Response to Submissions – 1-7 Rangers Road & 50 Yeo Street, Neutral Bay

This letter has been prepared by Ethos Urban on behalf of Fabcot, to address the matters raised in submissions prepared by the community, State Agencies and North Sydney Council in relation to the Planning Proposal (PP-2022-4350) at 1-7 Rangers Road & 50 Yeo Street, Neutral Bay.

Figure 1 Clear visual connection achieved between Yeo Street and Rangers Road

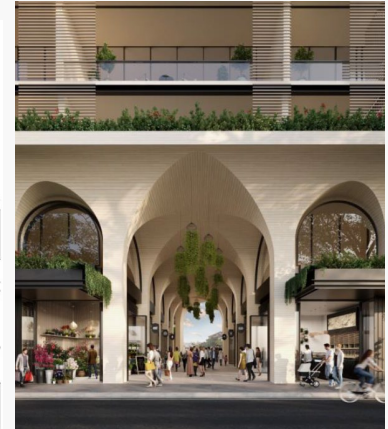
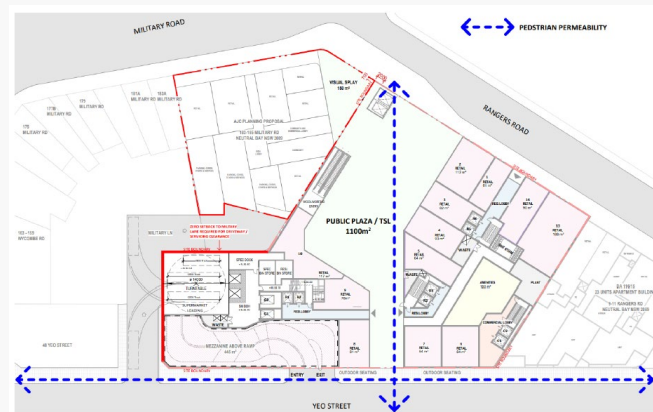
2. Escalators and lifts to be relocated to improve safety and amenity of the public space	<p>Council's concern that the proposed lift will result in a lack of visual connection from Rangers Road through to Yeo Street has previously been raised and significantly assessed and reviewed through the Planning Proposal process. As previously outlined to the Panel, the proposed escalators and lifts will enable direct sightlines and clear visual connection across the Site as shown in Figure 1 below. Therefore, the proposal will ensure safe and permeable pedestrian wayfinding. Further the proposed escalators and lifts are also essential in providing access and ensuring successful operations of the subterranean supermarket.</p>

Notably, Council's own draft NBVPS identifies a children's playground in the middle of public plaza which is considered likely to result in an even greater adverse wayfinding impacts and negatively impact the usability of the space. We therefore disagree wholeheartedly with the Council's assertion that a single public lift in the proposed location will have a major negative impact on the plaza area.

Overall, the provision and location of the proposed escalators and lifts will draw people into and through the Site and will increase foot traffic and vibrancy of the plaza. It therefore it is requested that Council's recommendation is not imposed on the Planning Proposal or future LEP Amendment.

Figure 1 Traffic movement comparison

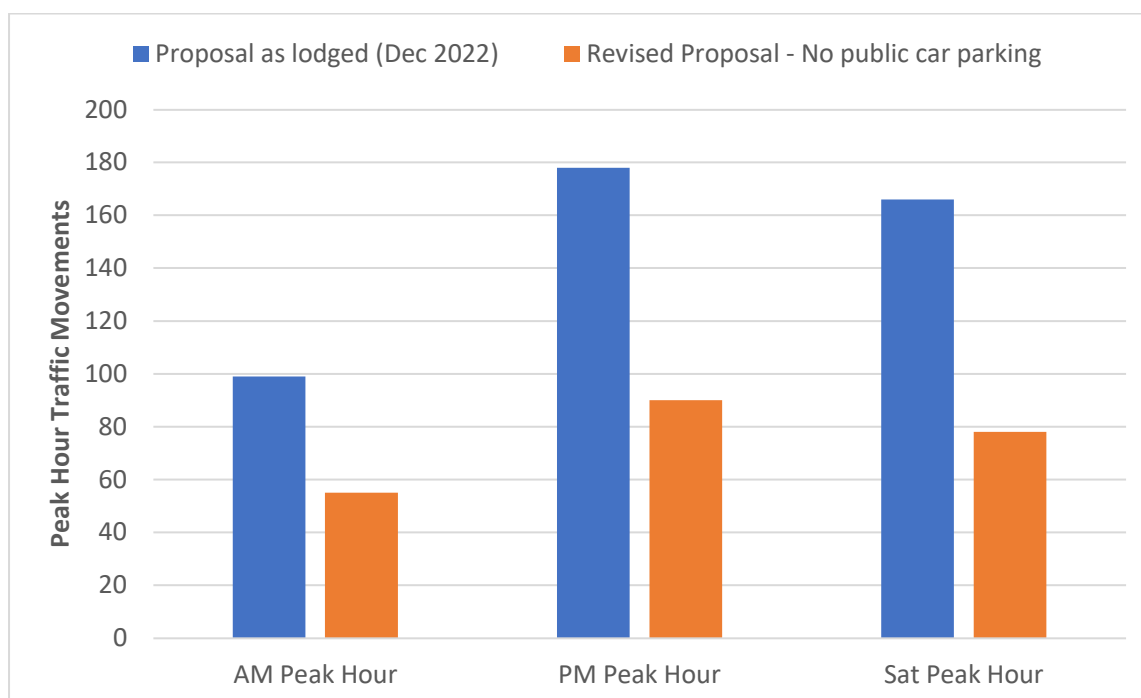
In relation to Item 5 of the TfNSW letter (Transport and Traffic Modelling), in response to feedback from TfNSW, updated traffic modelling has been undertaken and is presented in the revised transport impact assessment (TIA) document which is attached to this letter. This traffic modelling has been updated following feedback received from TfNSW in June 2024, with responses to the modelling comments provided as Appendix A of the updated TIA.

It should be noted that the removal of the 88 public car parking spaces has significantly reduced the extent of traffic generation arising from the proposal, with this summarised in Figure 1 on the following page.

The modelling demonstrates minimal changes in the operation of surrounding intersections with the development of the site as envisaged under the Planning Proposal. Importantly intersections along Military Road are forecast to experience no material change in operational performance – with existing levels of service retained in all peak hours assessed. Traffic modelling outputs are summarised in Section 4.3 of the updated TIA and reproduced on the following pages of this letter, with detailed traffic modelling outputs provided in Appendix B of the updated TIA. The modelling undertaken therefore indicates that the proposal is not anticipated to result in unacceptable traffic impacts on the surrounding road network.
